Telecommunications and Information Exchange Between Systems

ISO/IEC JTC 1/SC 6

Document Number:	N14109
Date:	2009-10-13
Replaces:	
Document Type:	Disposition of Comments
Document Title:	Disposition of Comments on ISO/IEC DIS 13157, Information technology -- Telecommunications and information exchange between systems -- NFC-SEC: NFCIP-1 Security Services and Protocol
Document Source:	Project Editor
Project Number:	
Document Status:	For your information.
Action ID:	FYI
Due Date:	
No. of Pages:	24
ISO/IEC JTC1/SC6 Secretariat Ms. Jooran Lee, KSA (on behalf of KATS) Korea Technology Center #701-7 Yeoksam-dong, Gangnam-gu, Seoul, 135-513, Republic of Korea ; Telephone: +82 2 6009 4808 ; Facsimile: +82 2 6009 4819 ; Email : jooran@kisi.or.kr

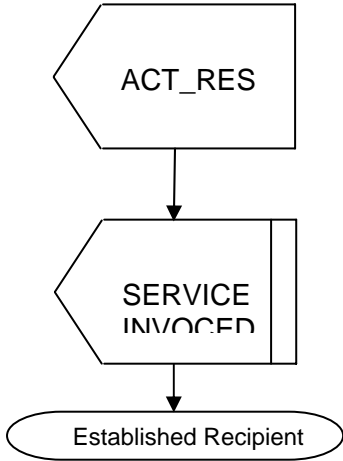
FR33	Annex A.3	List of SDUs	Te	<p>When the Recipient receives the PDU ACT_REQ and answers with a PDU ACT_RES , an SDU should be sent to the NFC-SEC USER to report that a NFC-SEC Service has been requested. This information informs the USER layer that the NFC-SEC entity has moved to the “Established Recipient” State and is no longer able to receive the SDU of the Idle State (refer to FR comment</p> <p>This SDU should include the type of the service and the Security Context Identifier</p>	<p>Add the following Confirm SDU to the list</p> <p>“Service Invoked</p> <p>Indicates the receipt of a Service Request (type of service, SCID)”</p>	<p>Rejected</p> <p>The NFC-USER is informed by the ESTABLISHED SDU. Collisions during the estgablshment phase are resolved by ERROR SDU indications.</p>
FR34	Annex A.4	A.4.1	Te	<p>In the IDLE state no PDU conveying a ERROR is expected to be received. The IDLE state is either the initial state or the state acquired after a PDU ERROR is sent or received</p>	<p>Delete</p> 	<p>Rejected.</p> <p>Due to timing, an ERROR PDU may be received immediately after transit to the IDLE state. See also 12.1.</p>
